TARAHUMARA SUBDIVISION FILING NO. 1

JOB NO	954-1
CAD NO	954-1
DATE	02/13/24
PHASING PLAN	2260 ANDES WAY
	AURORA, CO 80011

**TARAHUMARA TRUCKING**

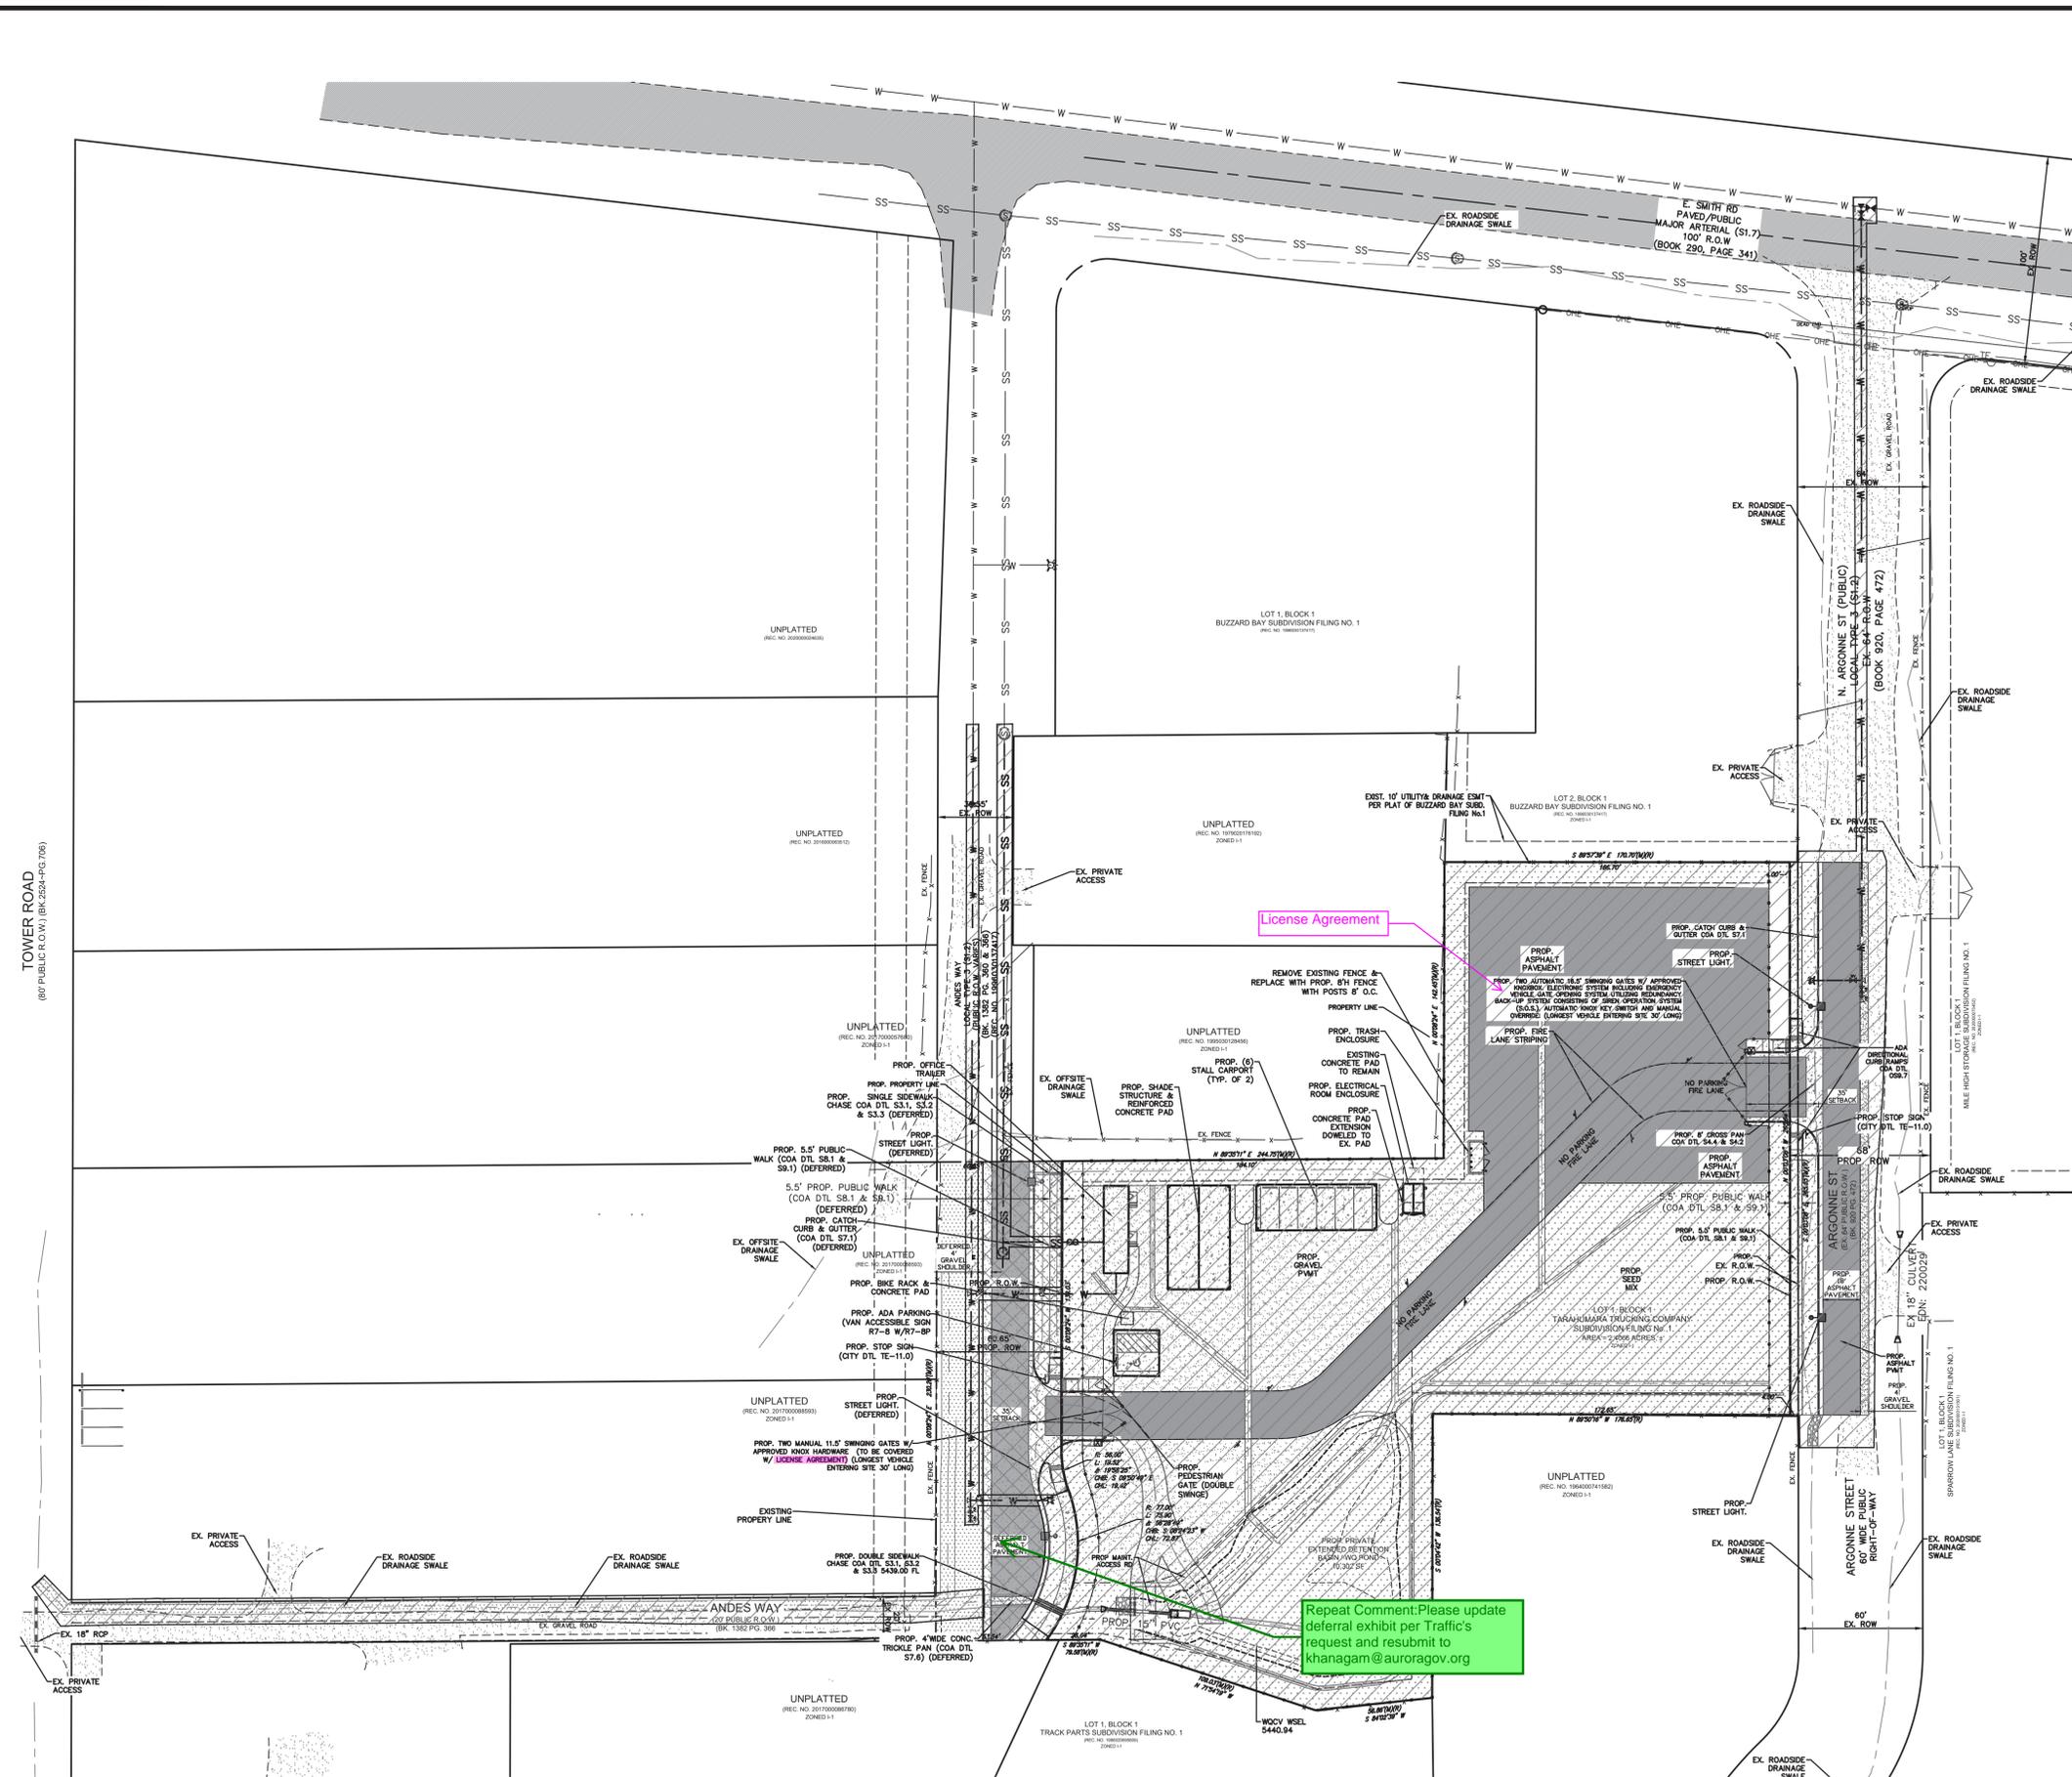
Repeat Comment: Please update deferral exhibit per Traffic's request and resubmit to khanagam@auroragov.org

UTILITY PLAN	JOB NO	954-1
2260 ANDES WAY	CAD NO	954-1
AURORA, CO 80011	DATE	02/13/24

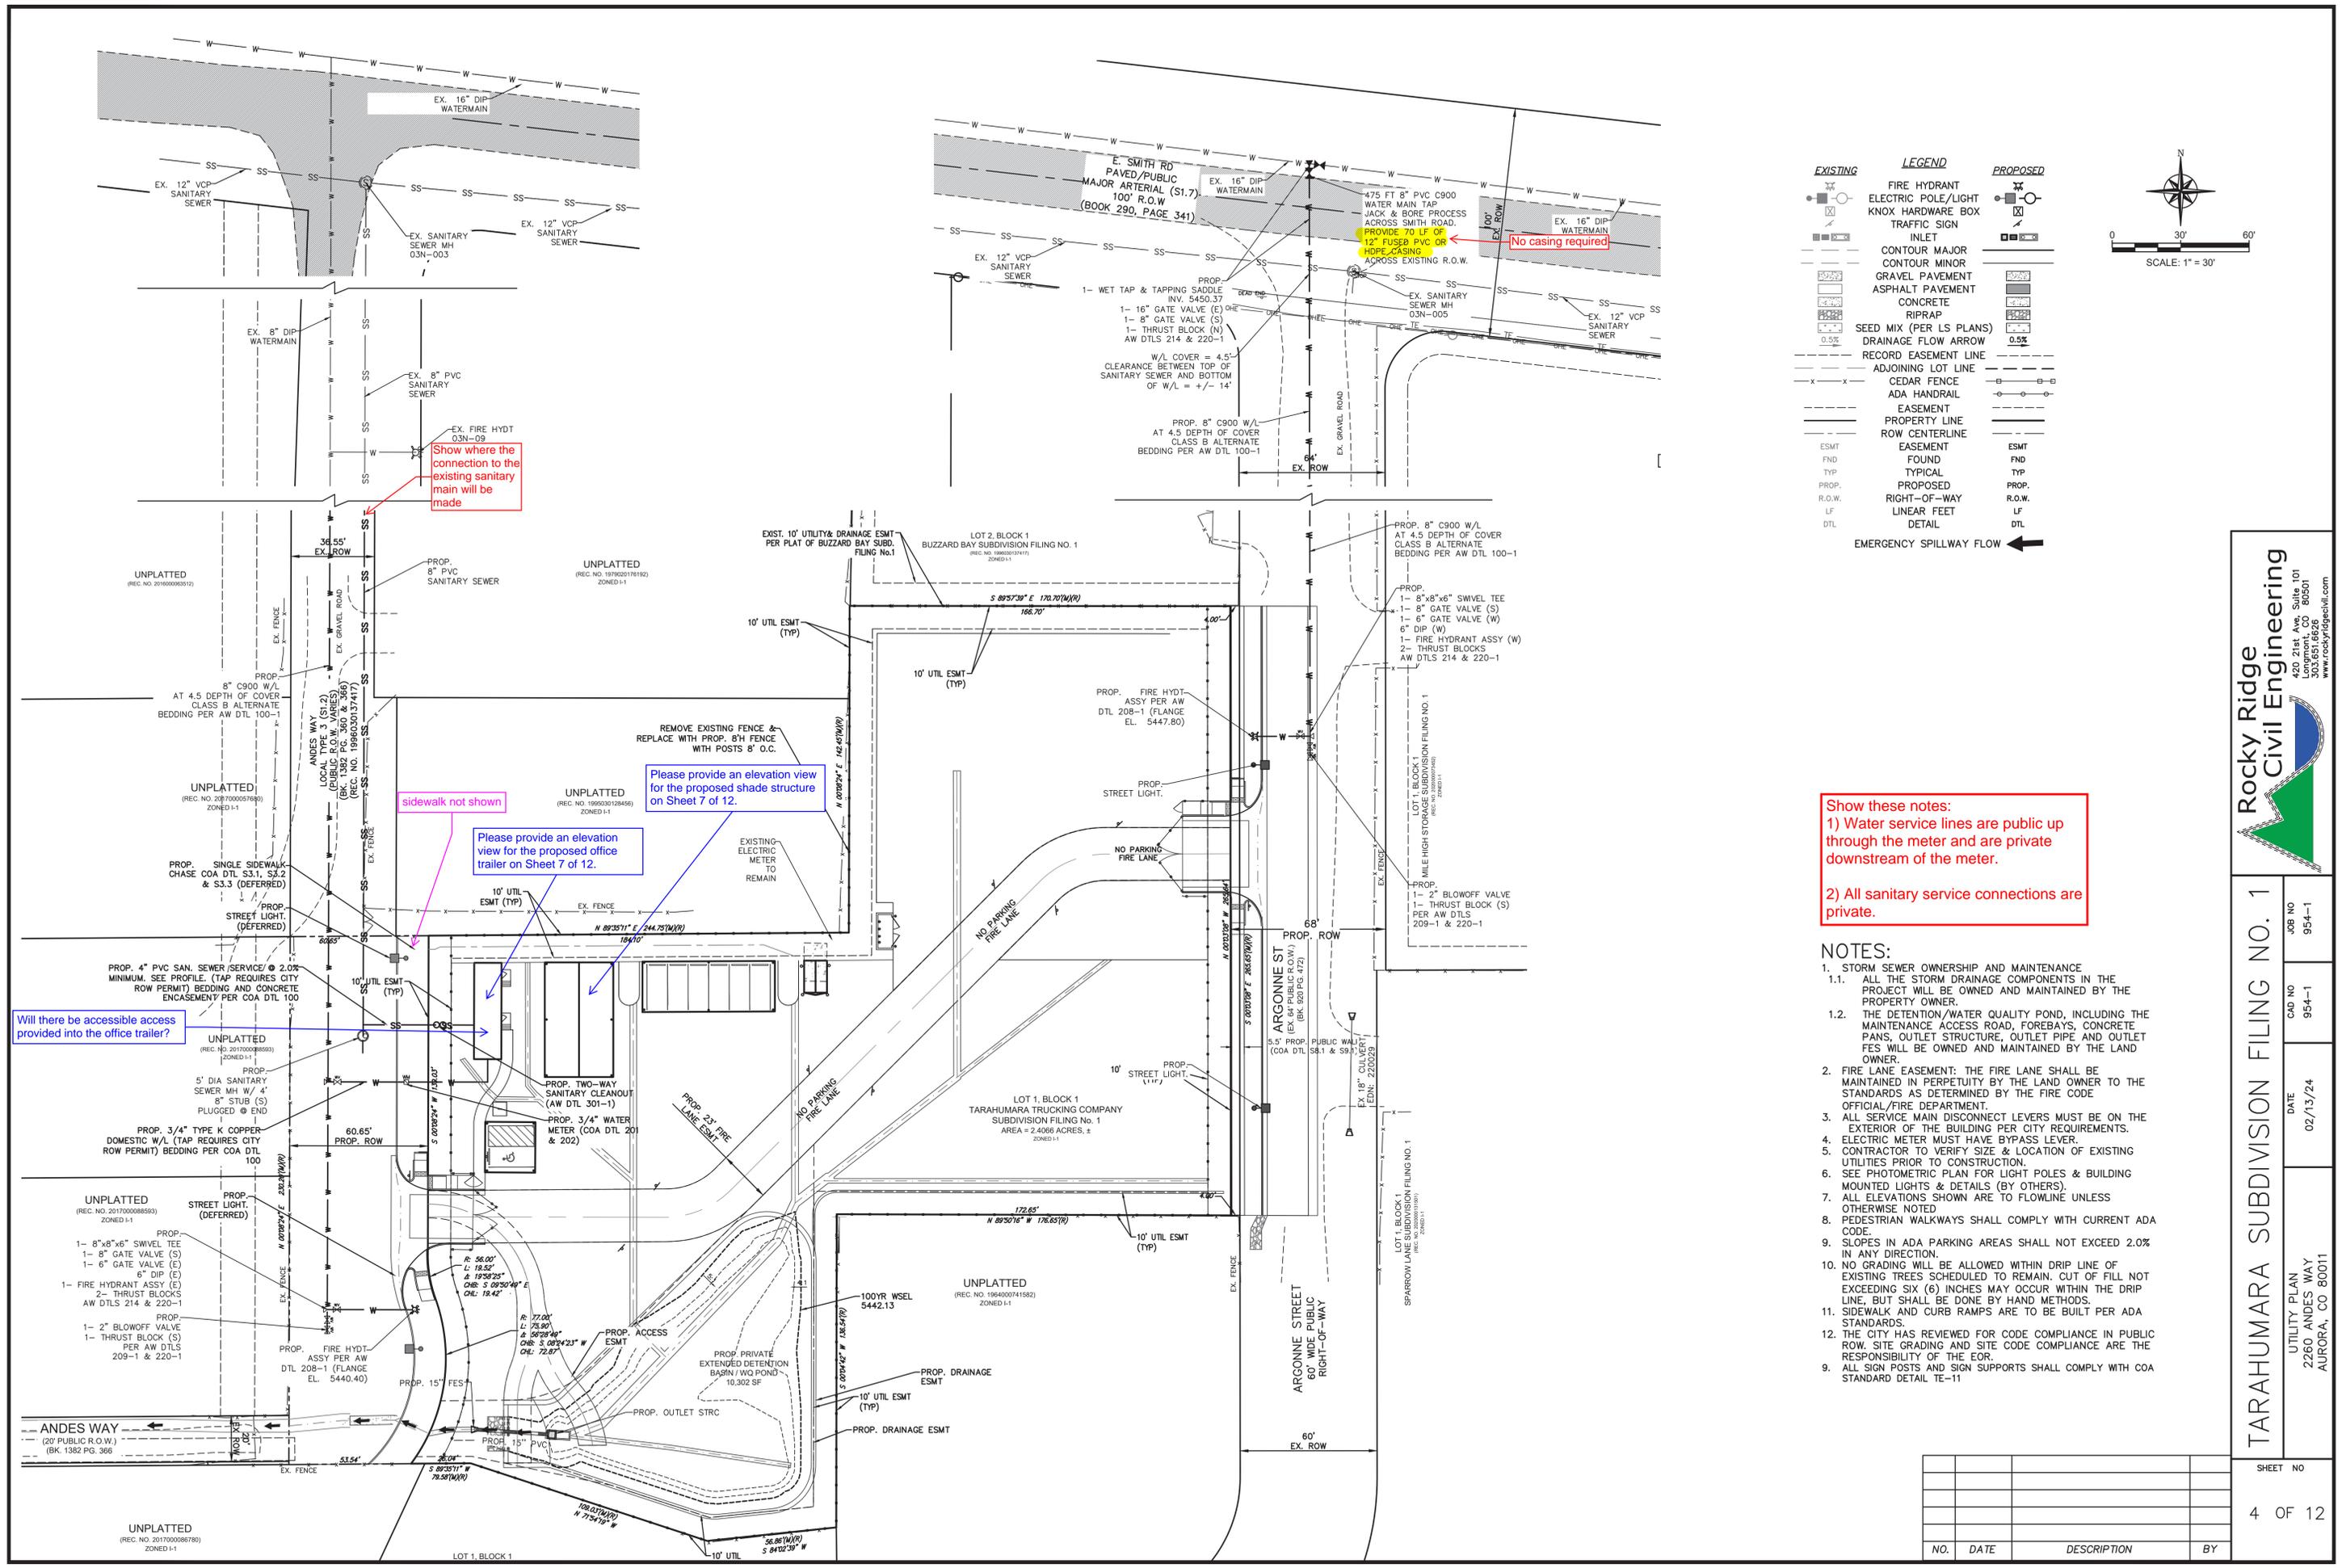
Show these notes:  
 1) Water service lines are public up through the meter and are private downstream of the meter.  
 2) All sanitary service connections are private.

**TARAHUMARA SUBDIVISION FILING NO. 1**  
 INTERIM GRADING PLAN  
 2260 ANDES WAY  
 AURORA, CO 80011

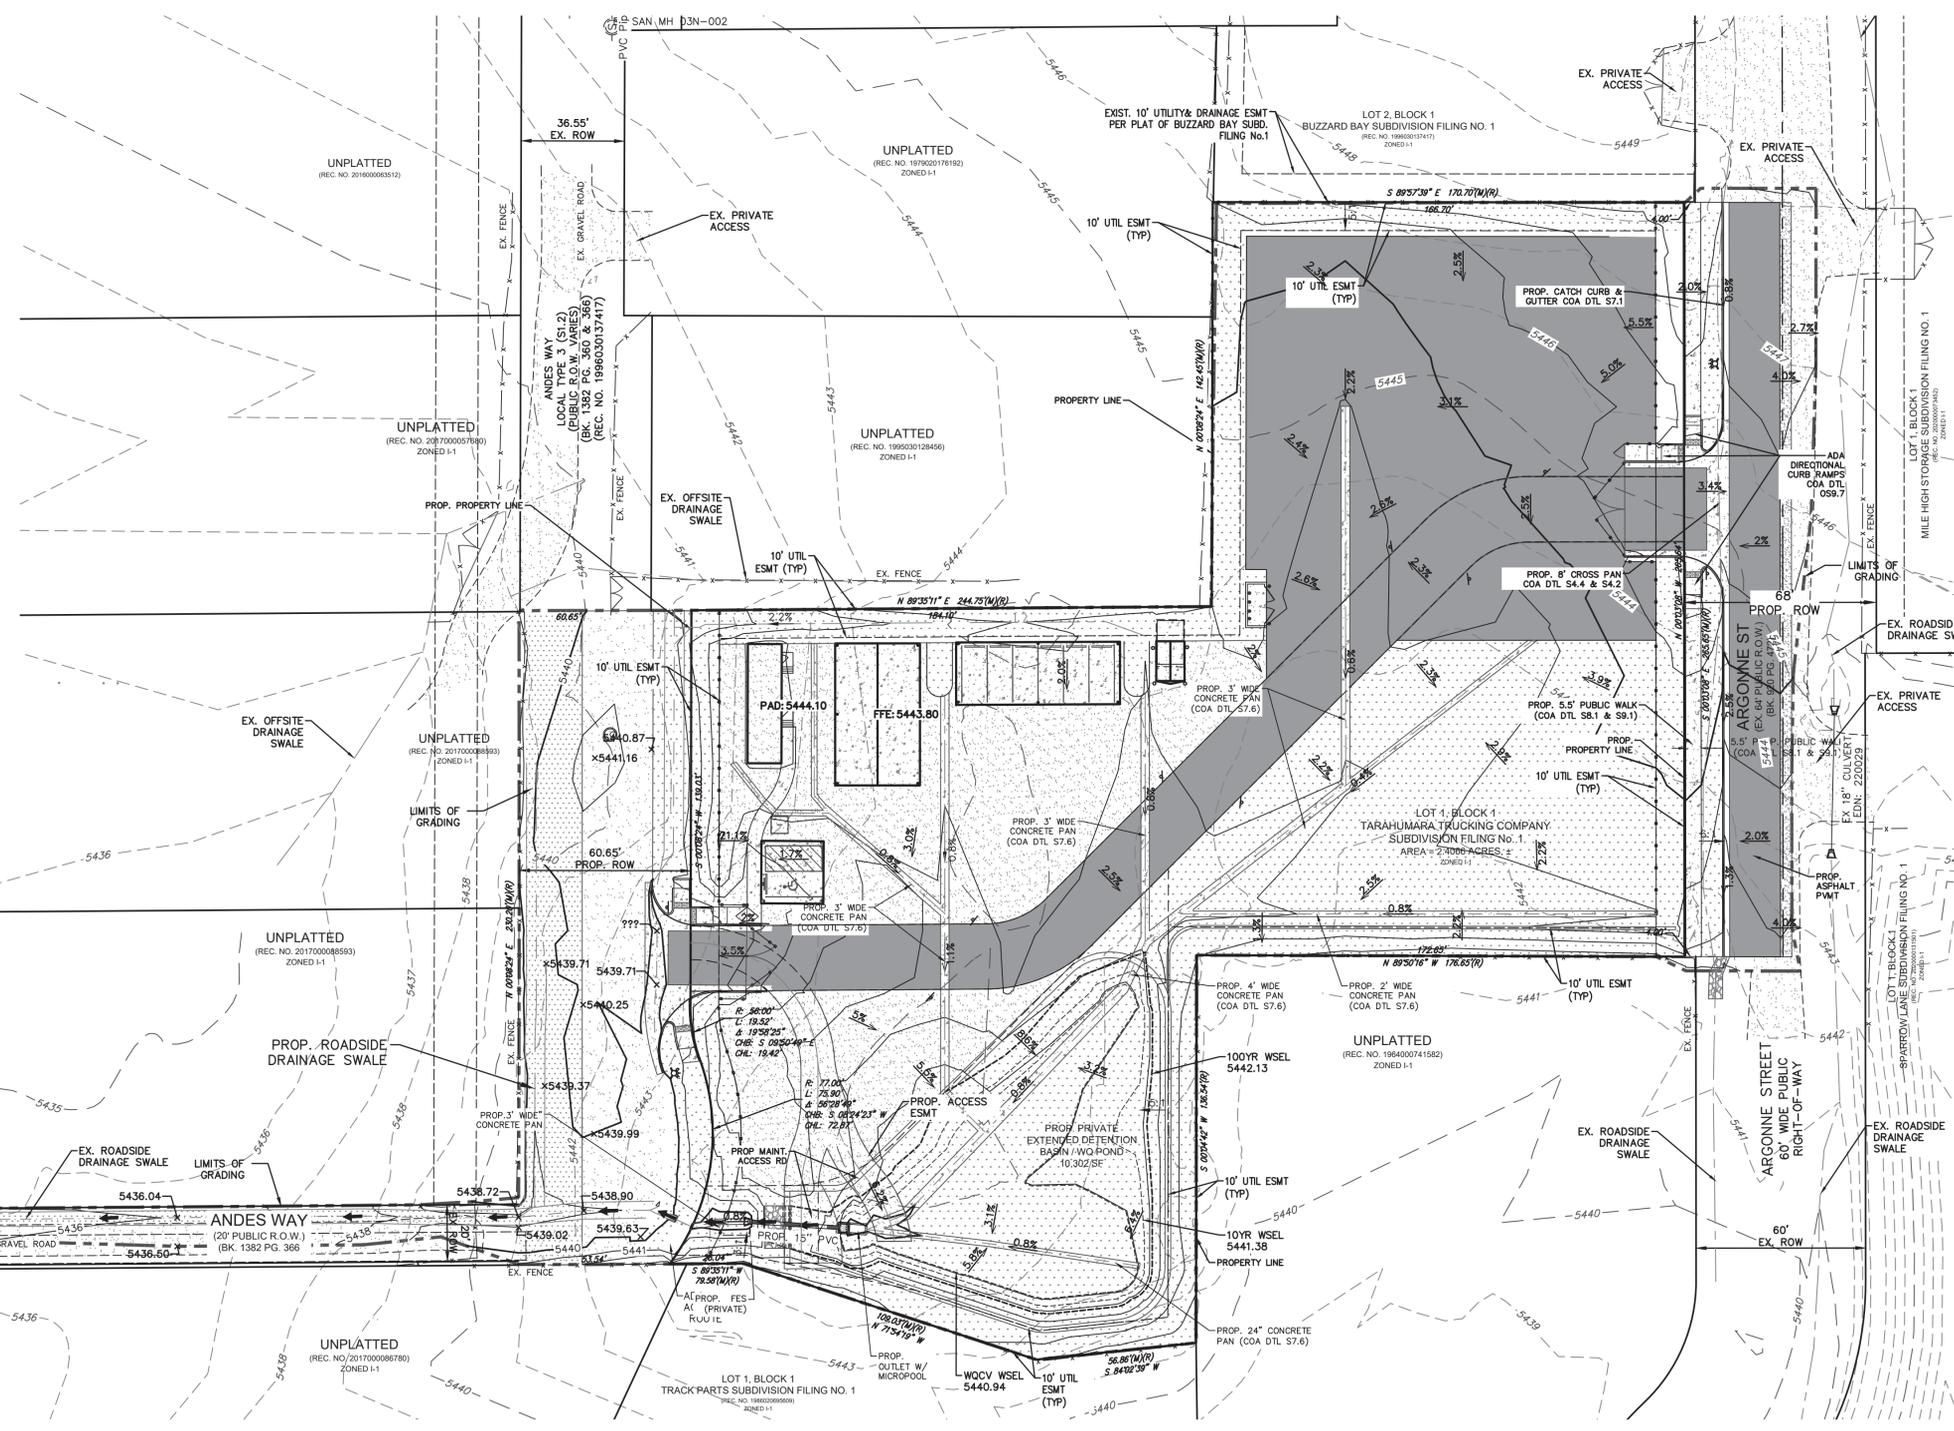
- THE CITY **Repeat Comment:** IR CODE COMPLIANCE IN PUBLIC ROW. SITE IR CODE COMPLIANCE ARE THE RESPONSIBILITY OF THE EOR.

- Please add the following notes:
- Minimum slope on unpaved areas is 2%, minimum slope on asphalt is 1%, and minimum slope on concrete is 0.5%.
  - The maximum slope within ROW is 4:1, the maximum slope for property outside of the ROW is 3:1.

- The slope away from the building shall have a minimum grade of five (5) percent for the first ten feet or to the property line, whichever occurs first, then a minimum of two (2) percent until the slope reaches the swale around the building. If physical obstructions or lot lines prohibit the ten feet of horizontal distance, a five (5) percent slope shall be provided to an approved alternative method of diverting storm runoff away from the foundation. Impervious surfaces within ten feet of the building foundation shall be sloped a minimum of two (2) percent away from the building.

- The maximum permissible longitudinal grade for fire lanes is 10%. The maximum transverse grade for a fire lane is four percent with a resultant maximum slope of ten percent.

- The resultant grade in any direction within accessible parking areas shall not exceed two percent.
  - The maximum cross slope in an accessible path shall not exceed two percent. The maximum longitudinal slope along an accessible path shall not exceed five percent.

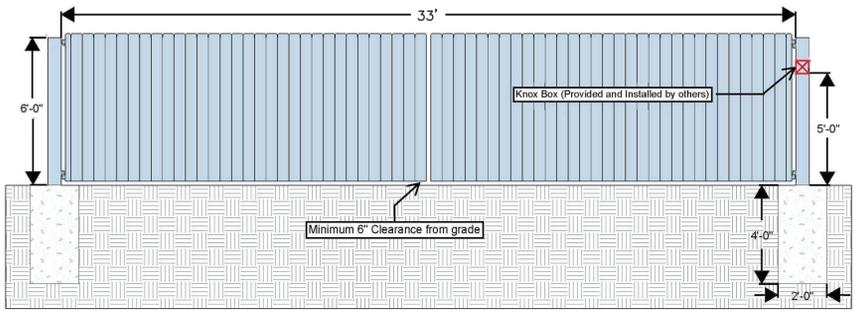
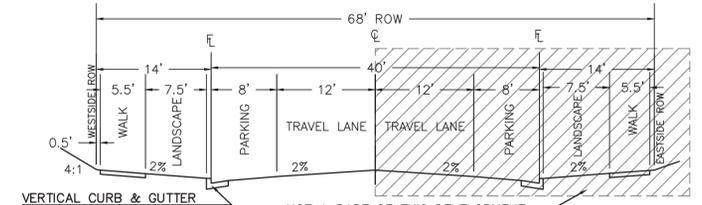
Please provide an elevation view for the proposed shade structure.
